December 30, 2022
REPLACEMENT OF BRIDGE NO. 68-002, 68-003 & 68-009
STATE PROJECT NO. 9068-0002, 9068-0003
& 9068-0009
TOWN OF KILLINGLY

ADDENDUM NO. 4

REQUEST FOR INFORMATION

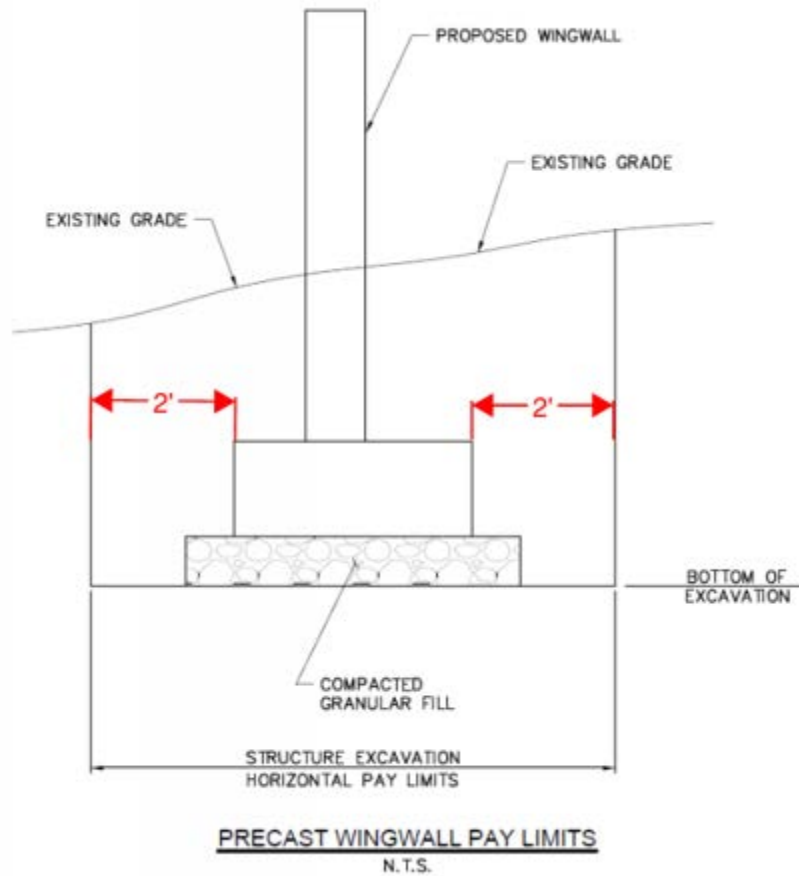
13. What are the dimensions of the horizontal pay limits of structural excavation for the wingwalls? They are not shown on detail sheet MDS-3.

The structure excavation pay limits for the wingwalls are set by a 2' horizontal offset from each face of the wingwall footing. See detail attached.
